# Dry Creek Watershed Plan Update

## Design Memorandum

RE: Dry Creek Watershed Plan Update

**Project Name and Number:** 29001 Dry Creek Watershed Project  
**Client Name:** Civil Engineering Solutions, Inc.  
**Contact Person:** Thomas Plummer, Jr., P.E.  
**Email Address:** [Thomasplummer@civilsolutions.org](mailto:Thomasplummer@civilsolutions.org)  
**Phone Number:** (916) 563-7300      **Fax:** (916) 563-7362

**Exhibit 4**  
**Potential Project**  
**Linda Creek upstream from Old Auburn Road**

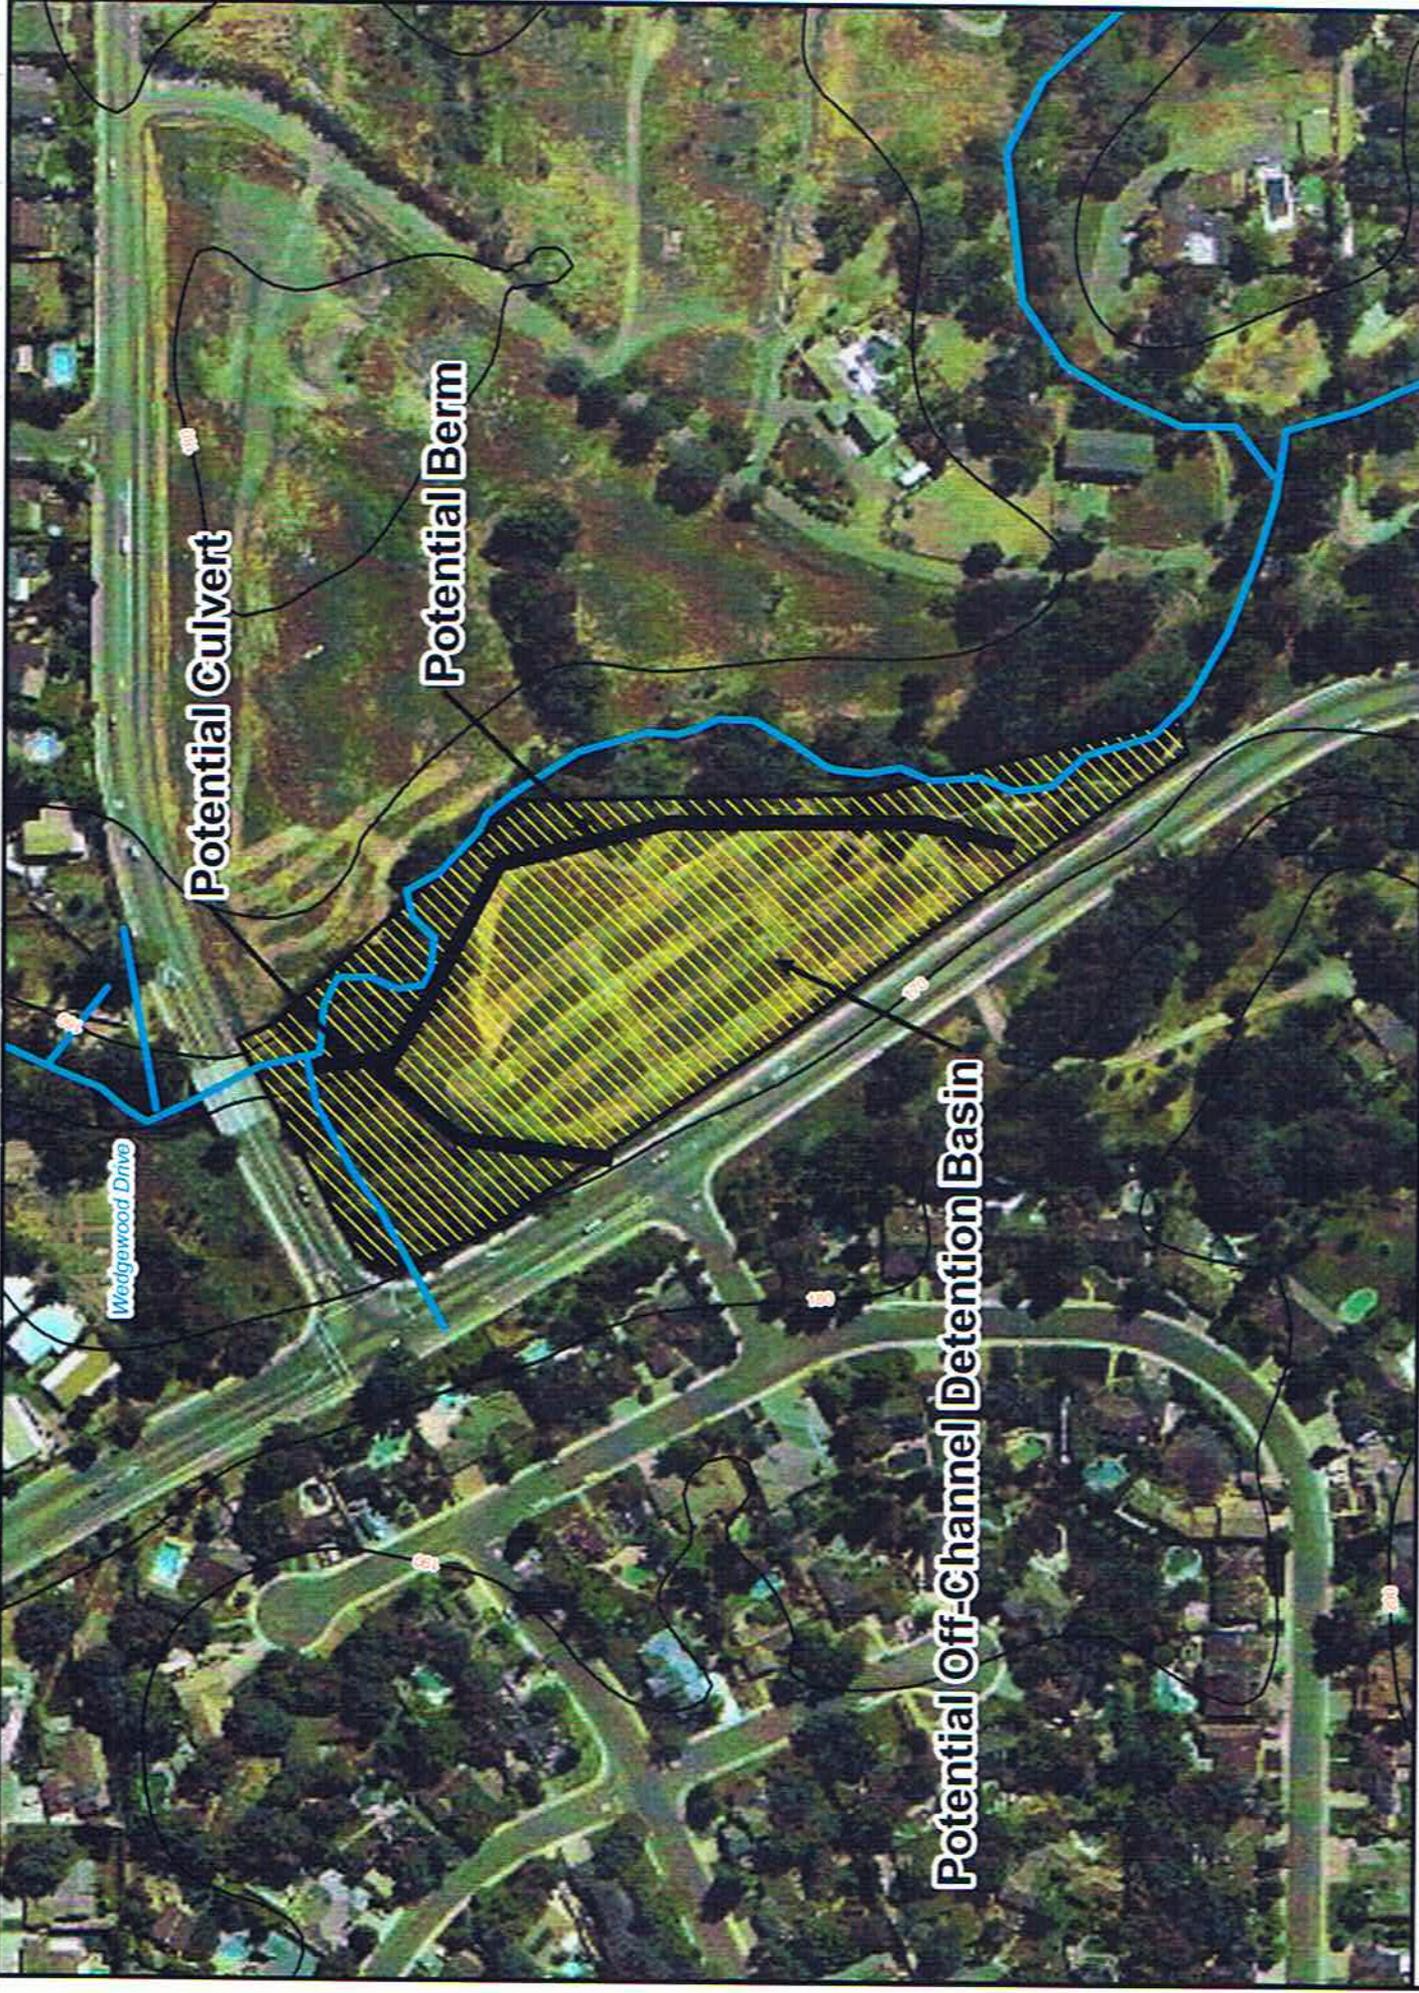
suitable for off-channel flood water detention is currently completely occupied by oak tree mitigation plantings regularly tended by City of Roseville personnel.

We believe that it is highly unlikely that the City of Roseville will support complete destruction of this mitigation site without the extraordinary expense of replacing the land area and all the trees and extending tree maintenance and tree survivorship guarantees for some considerable time into the future. The chosen site seems well suited for the type of installation proposed with the berm constructed from spoils excavated within the detention basin; however, we believe that do to its existing use for mitigation, Site E is not a good candidate for the flood control project and, unless cost is of no concern, should not be considered further.
